Informal document **GRBP-79-34-Rev.2**
(79th GRBP, 6-9 February 2024,
agenda item 6)

Proposal to amend ECE/TRANS/WP.29/GRBP/2024/2

Regulation No. 138

Uniform provisions concerning the approval of Quiet Road Transport Vehicles with regard to their reduced audibility (QRTV)

Figure 4

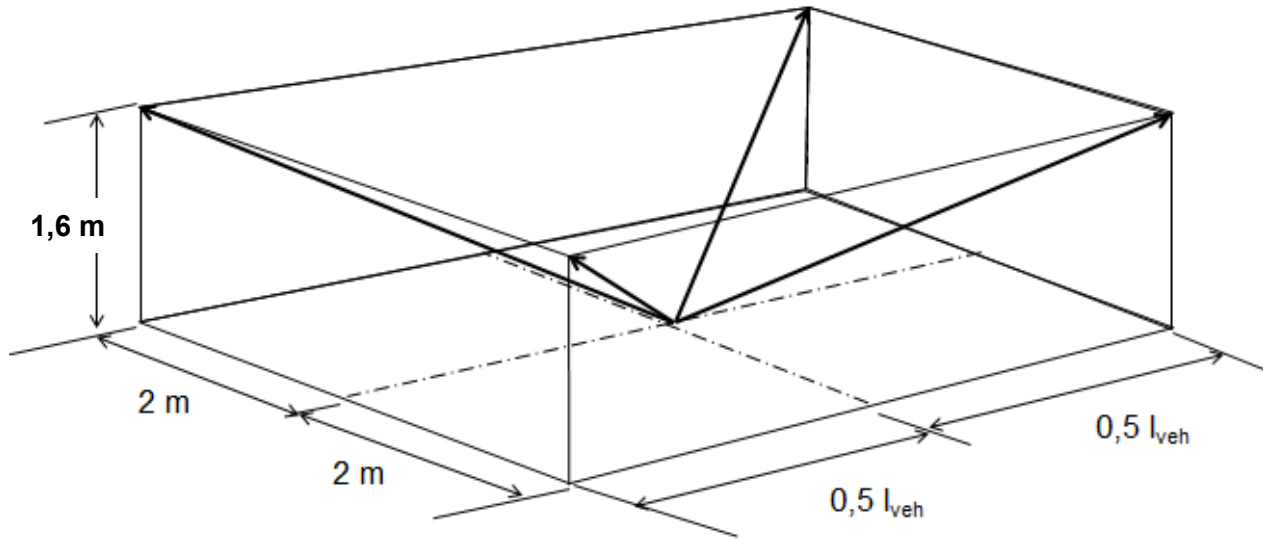
Background Noise Measurement ~~Determination of the range of background noise~~

Figure 6

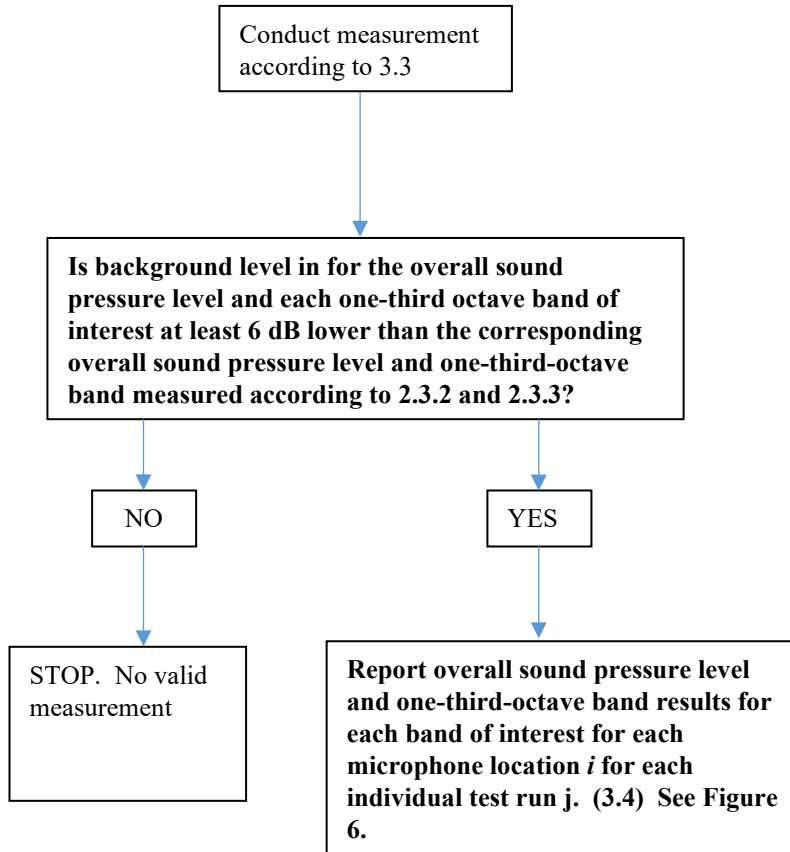
As an aid for background noise requirements when analyzing in one-third-octave bands see flowchart in Figure ~~6~~5 of the Appendix to this annex.
